Consumers
Power
Company

February 8, 1978

DOCKET 50-155 - LICENSE DPR-6 -
BIG ROCK POINT PLANT -
SITE METEOROLOGY

**BIG ROCK POINT PLANT
OFF GAS 1976 - 1977**

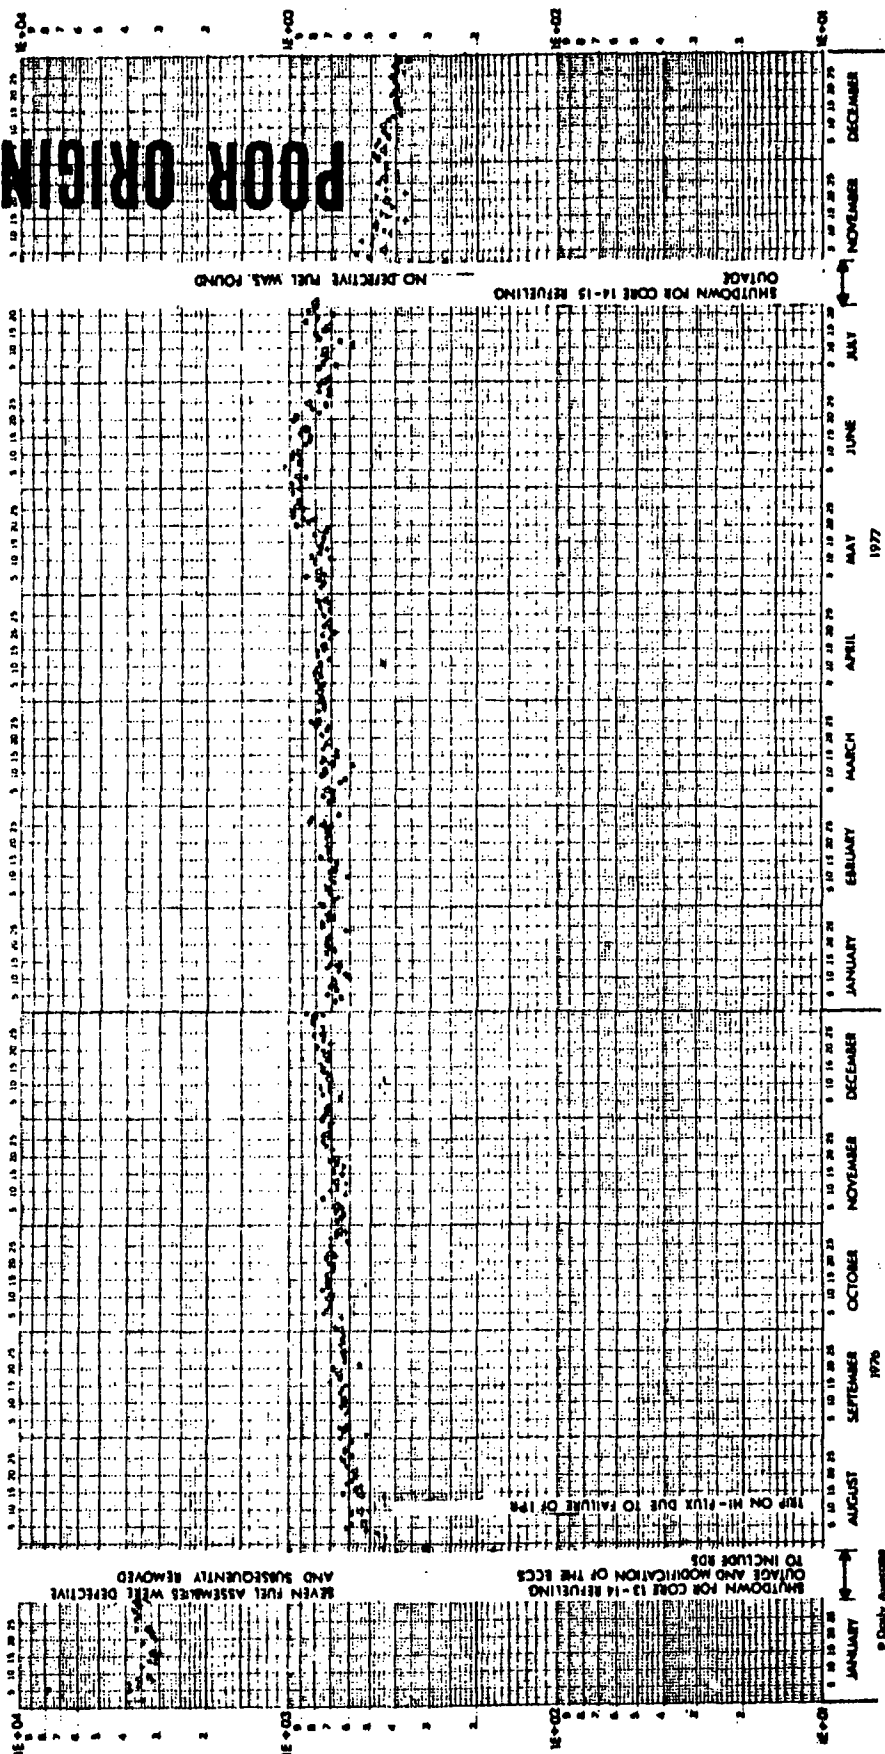
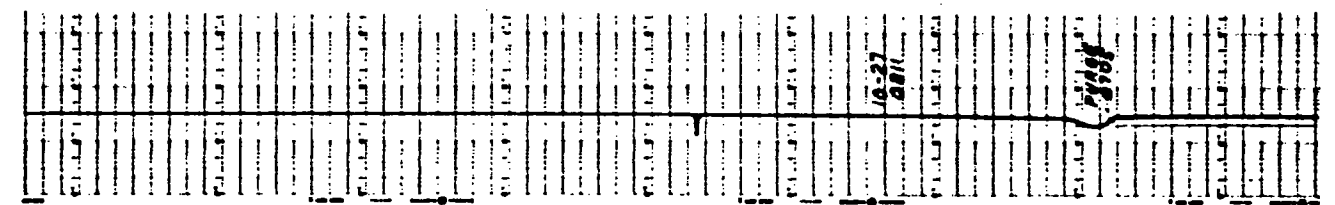
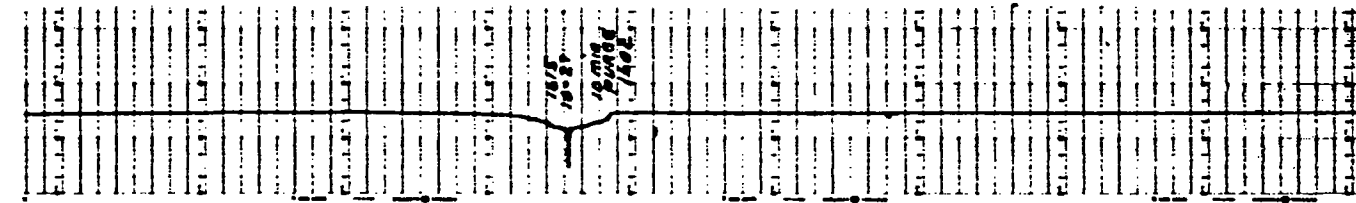
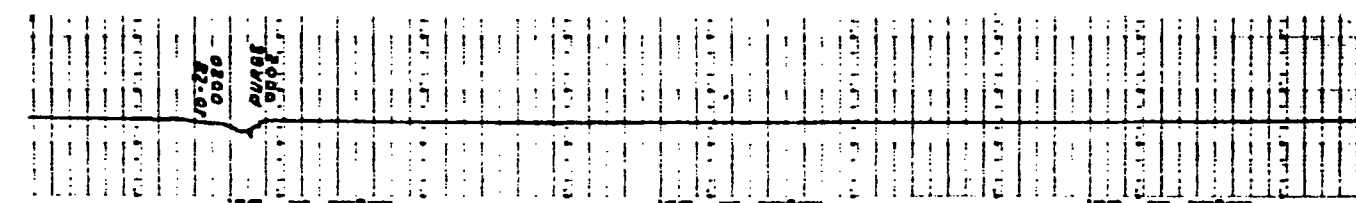
It is the intention of the NRC staff to use atmospheric effluent data over the period 1972 through 1977 as source term to project future off-site doses with respect to 10 CFR 50, Appendix I.

It is Consumers Power Company's position that effluent releases prior to 1976 are not applicable to future release rates. It is apparent that even the 1975 effluent data used in our June 4, 1976 Appendix I submittal is excessively conservative with respect to more recent years. Release rates have diminished progressively as indicated by Figure I due to fuel improvements and operational changes. These changes were described on Pages A-1 and A-2 of our original submittal and are updated in Table I, attached.

It is requested that the staff reconsider the use of data prior to 1976 and that the more appropriate 1976-1977 effluent release values be utilized for Appendix I calculations since, with the continued long-term reduction in effluent release, 1976-1977 values are expected to prove higher than the mean for future plant operation to end-of-life values. Thus, the recent data is considered realistically conservative and in conformance with Appendix I criteria.

Comparison of Monthly Average Temperatures at East Jordan

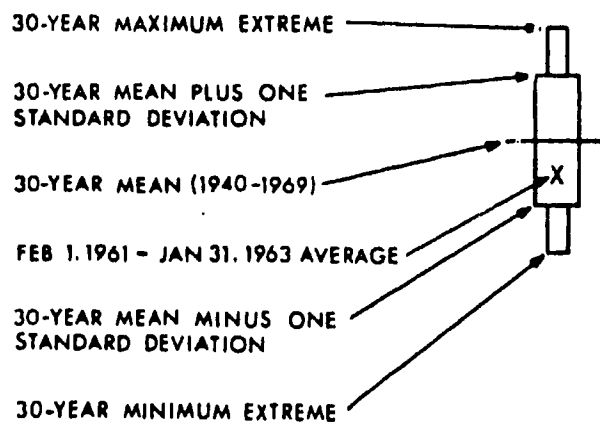
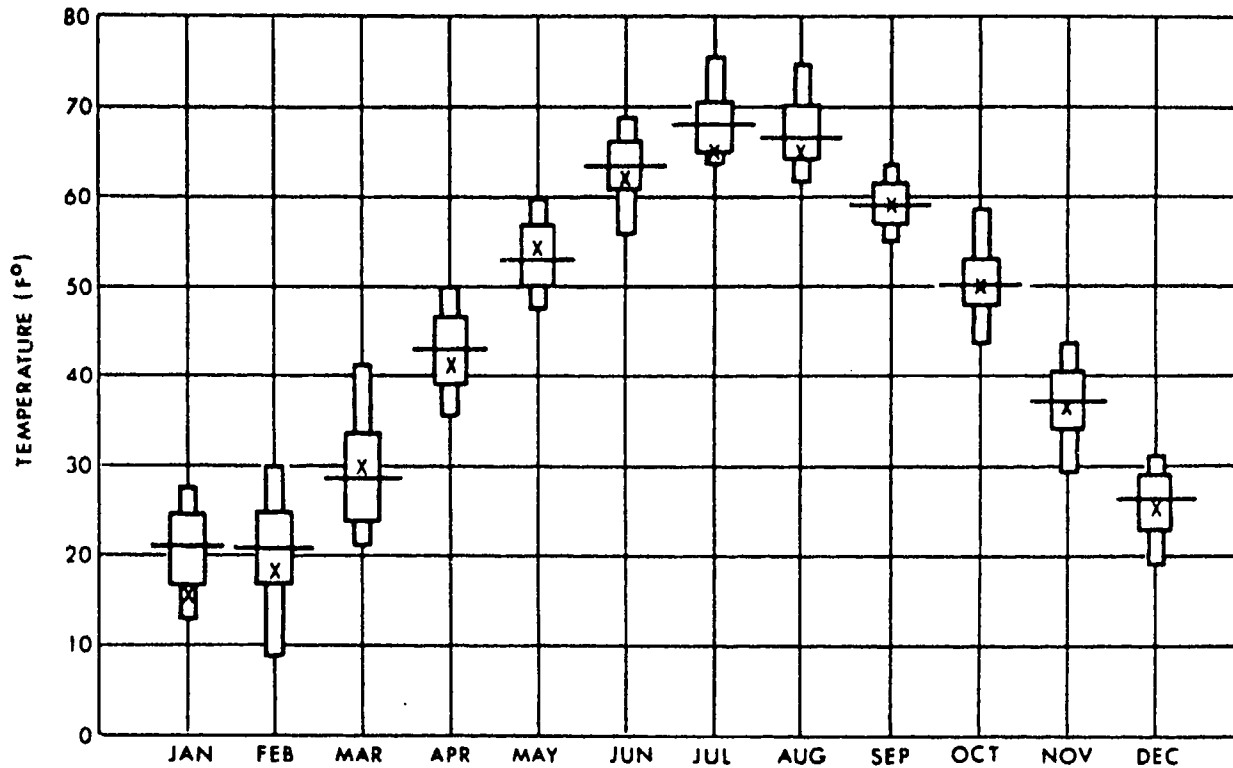
Does the meteorological data collection period (upon which the Appendix I submittal was based) represent long-term conditions in the vicinity of Big Rock Point?

Figures IV through VI present the mean monthly temperature and one standard deviation as compared to the 24-month period for each of the three stations. The figures show that the fluctuations in extremes are lower at East Jordan and Traverse City which are closer to water bodies (as is Big Rock) than Pellston which is inland.
